International Aero Engines SERVICE BULLETIN

Subject: Transmittal of Revision 1 to Service Bulletin Number
V2500-ENG-72-0306

ENGINE - LP COMPRESSOR - TO INCORPORATE BUSHES ON
THE LPC BLEED SYNCHRONIZING RING

V2500- ENG-72-0306

Figure 1

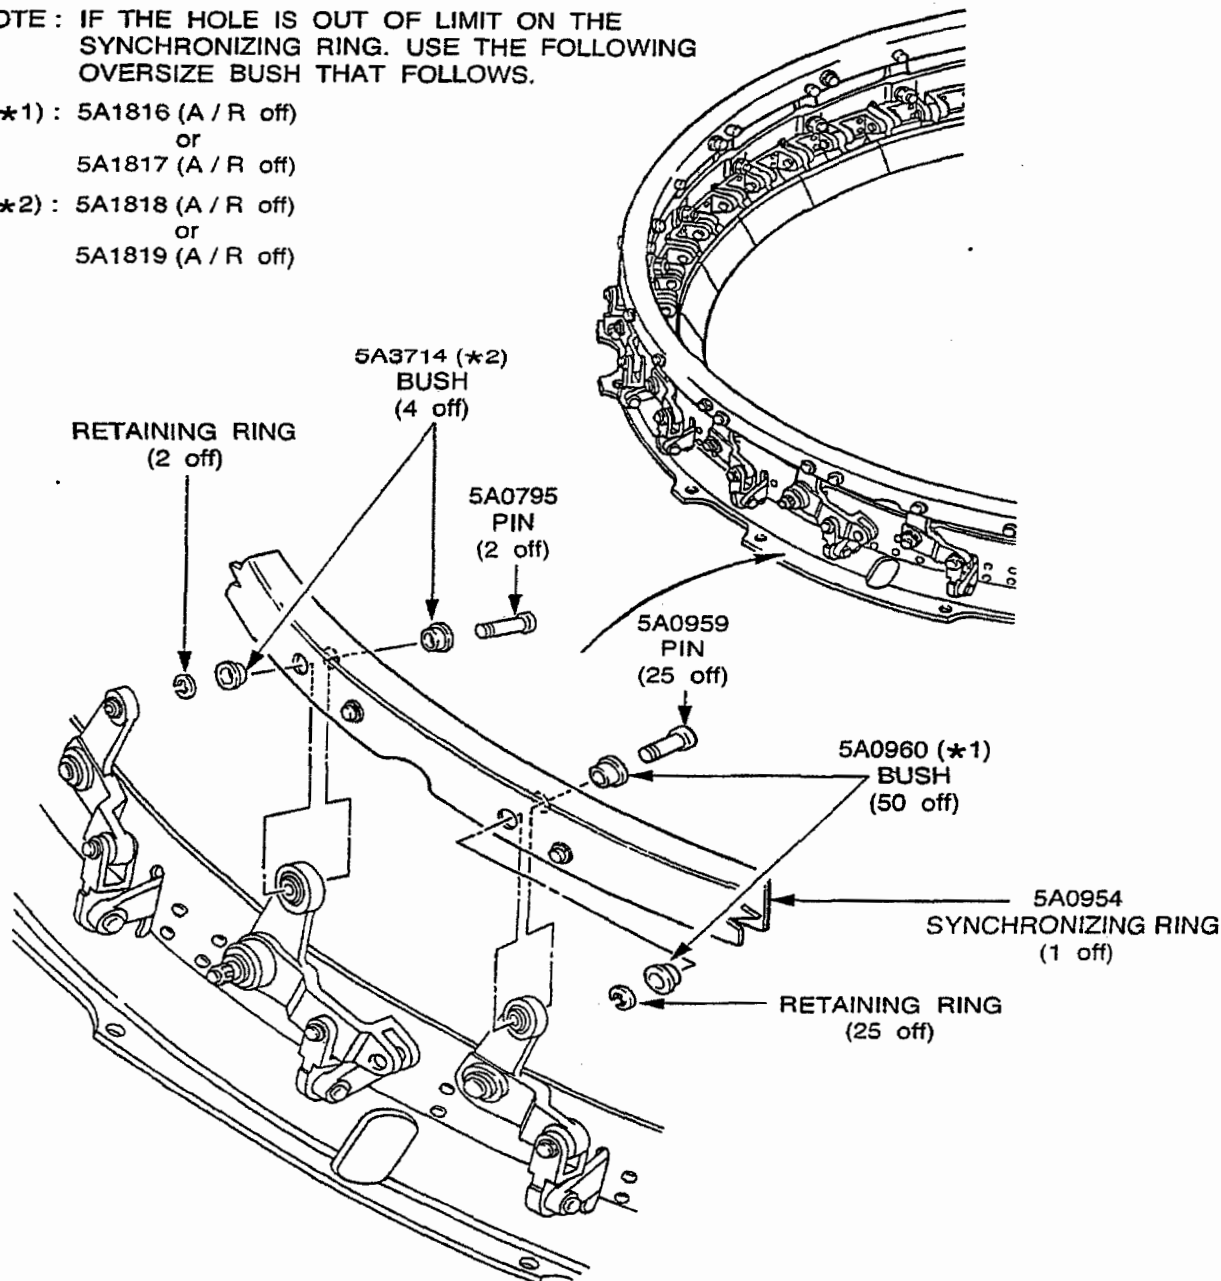
To replace *1 and *2 in Figure 1.

- (a) Additional 50 bushes are installed into the link arm holes on the synchronizing ring. (Refer to Figure 1)
- (b) At the same time, new oversize bushes are also introduced as a definition of repair of synchronizing ring.

- (1) Install the 50 5A0960, bushes in to the link arm holes of the 5A0954, synchronizing ring at all locations (Two at each location). For the correct procedures, refer to the A1 Engine Manual Chapter/Section 72-32-70, ASSEMBLY-01, CONFIG-1. (Refer to Figure 1)

NOTE : IF THE HOLE IS OUT OF LIMIT ON THE
SYNCHRONIZING RING. USE THE FOLLOWING
OVERSIZE BUSH THAT FOLLOWS.

(★1) : 5A1816 (A / R off)
or
5A1817 (A / R off)

(★2) : 5A1818 (A / R off)
or
5A1819 (A / R off)

Figure 2 (Sheet 1 of 5)

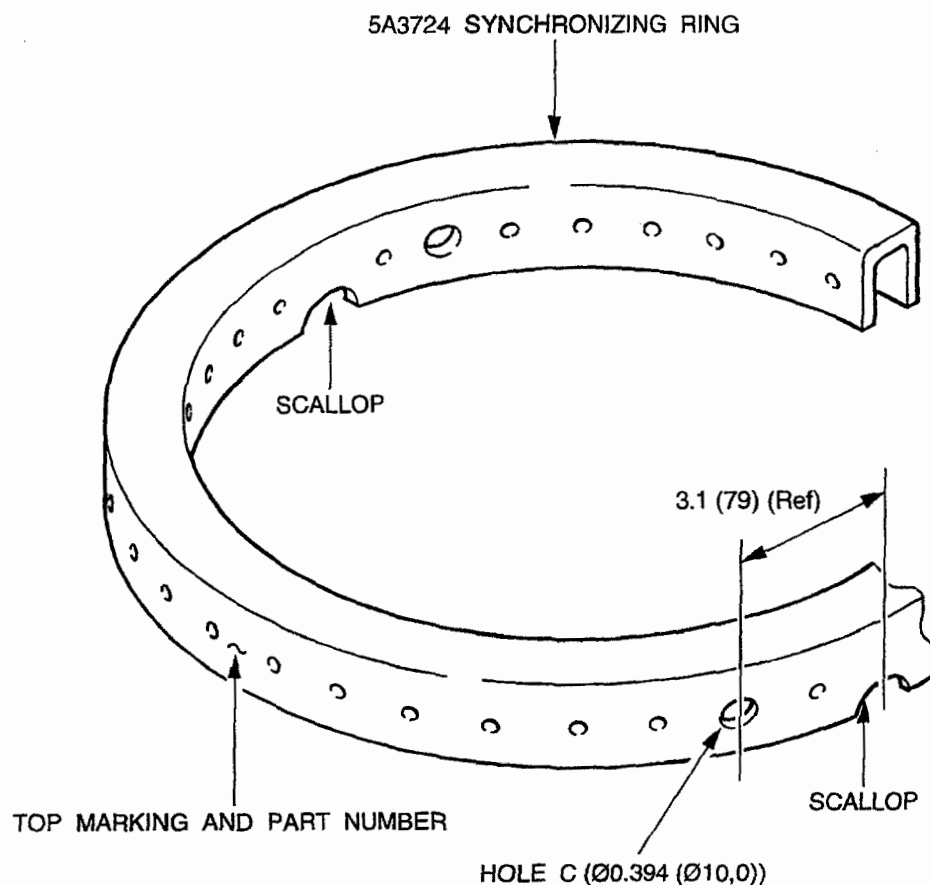
| <u>Procedures</u> | <u>Supplemental Information</u> |
|---|--|
| (c) Put the support equipment IAE3J12790, machining fixture onto the turn table. | Refer to the Facilities Equipment Manual Refer to Figure 2 (Sheet 1) |
| (d) Set the support equipment by the PLANE A and the Diameter B (DIA B). | Refer to Figure 2 (Sheet 1) |
| (e) Set and clamp the 5A3724, synchronizing ring with the open side down onto the IAE3J12790, machining fixture. Make sure that there is no clearance between the synchronizing ring and Plane A of machining fixture at each clamp position. | Refer to Figure 2 (Sheet 1) |

Figure 2 (Sheet 2 of 5)

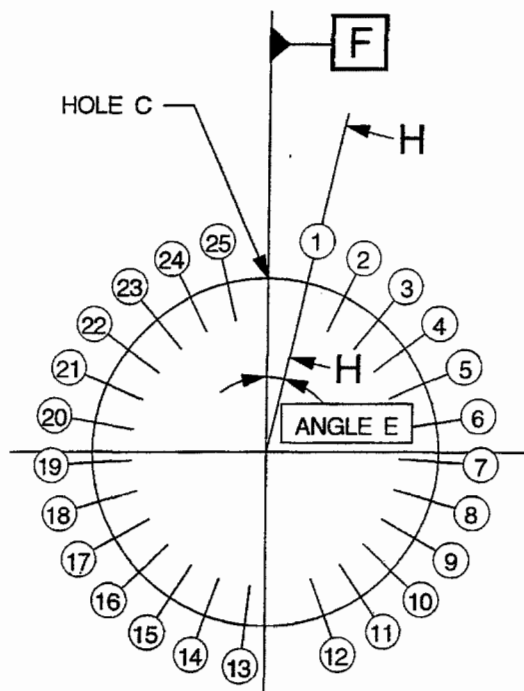
| <u>Procedures</u> | <u>Supplemental Information</u> |
|---|--|
| (f) Find a 'Top' marking and two scallops on the synchronizing ring, and adjust the zero degree of the turn table to the center of hole 'C'. | Refer to Figure 2 (Sheet 2 and 3) |

Figure 2 (Sheet 4 of 5)

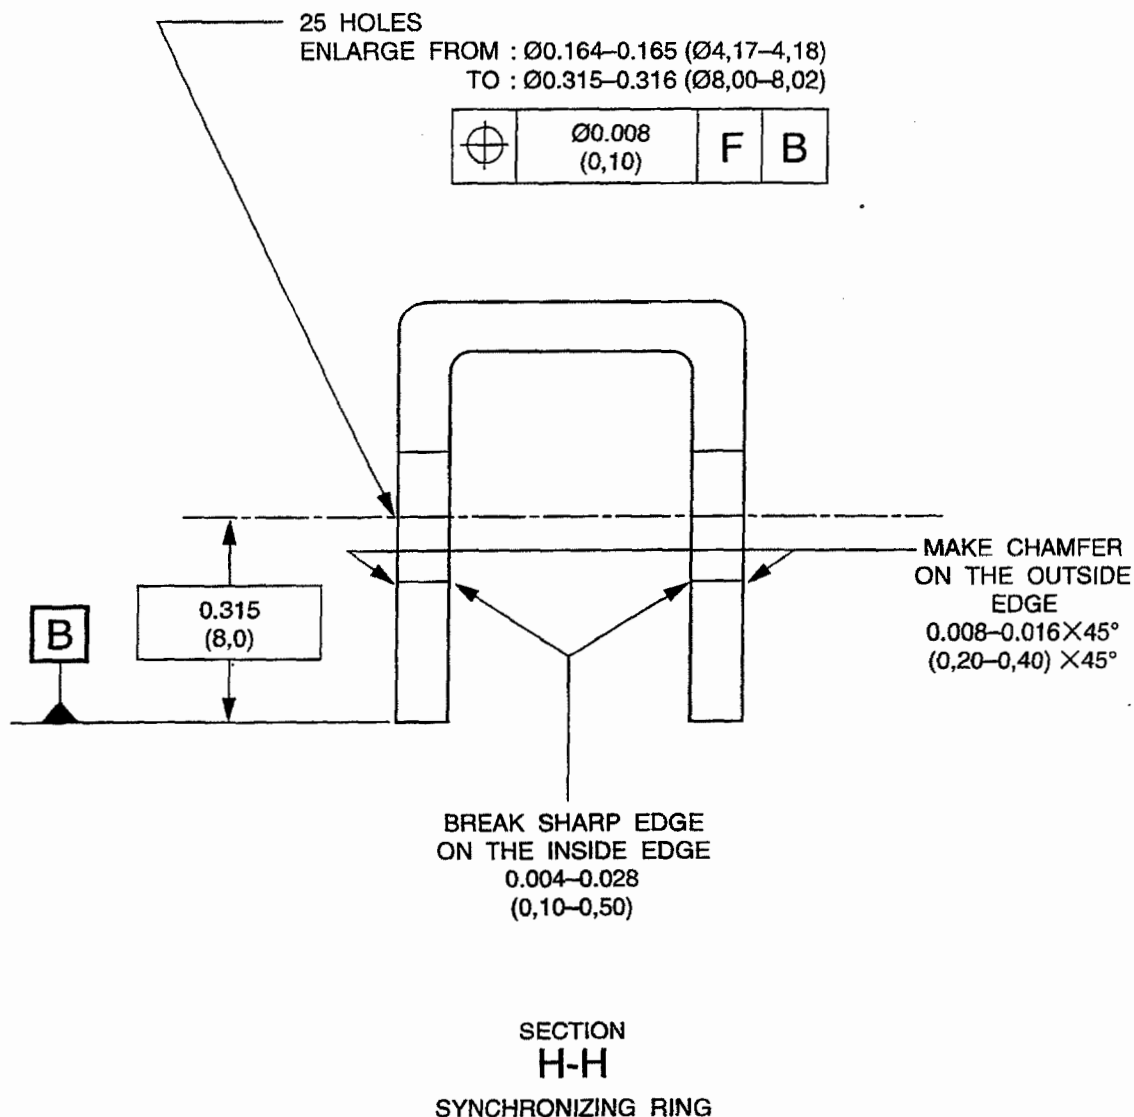
| <u>Procedures</u> | <u>Supplemental Information</u> |
|---|--|
| (g) Enlarge 25 holes on the synchronizing ring with a drill. Make sure that the drill center aligns with each existing hole. | Refer to Figure 2 (Sheet 4) |

- (h) Remove the synchronizing ring from the machining fixture.
- (i) Make chamfer on the outside edge of each hole. Break the sharp edge on the inside edge of each hole. Refer to Figure 2 (Sheet 4)

Figure 2 (Sheet 5 of 5)

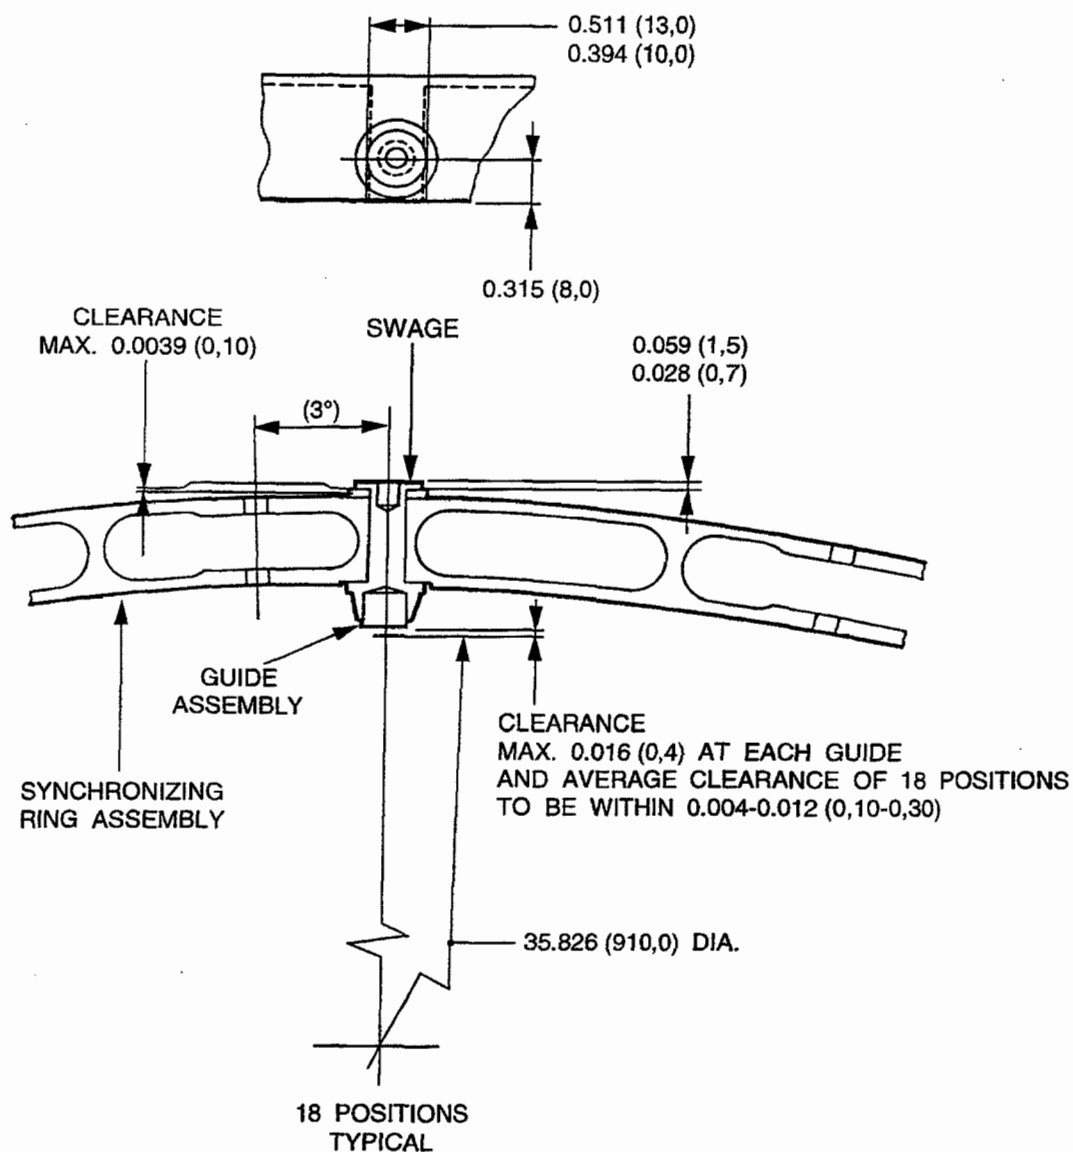
| <u>Procedures</u> | <u>Supplemental Information</u> |
|---|--|
| (a) Remove the 5A3699 guide assembly and MS15795, washer from the synchronizing ring. Discard the guide, but keep the washer. | Refer to the A1 Engine Manual Chapter/Section 72-32-73 Repair 002, VRS1336 Refer to Figure 2 (Sheet 5) |

- (k) Install the 5A0956, guide assembly and the MS15795-809, washer onto the synchronizing ring. Refer to Figure 2 (Sheet 5)
Refer to the A1 Engine Manual, Chapter/Section 72-32-73, Repair 002, VRS1336.
Use the IAE3J12850 peening tool

- (m) Visually and dimensionally examine the formed guide assembly. Refer to Figure 2 (Sheet 5)
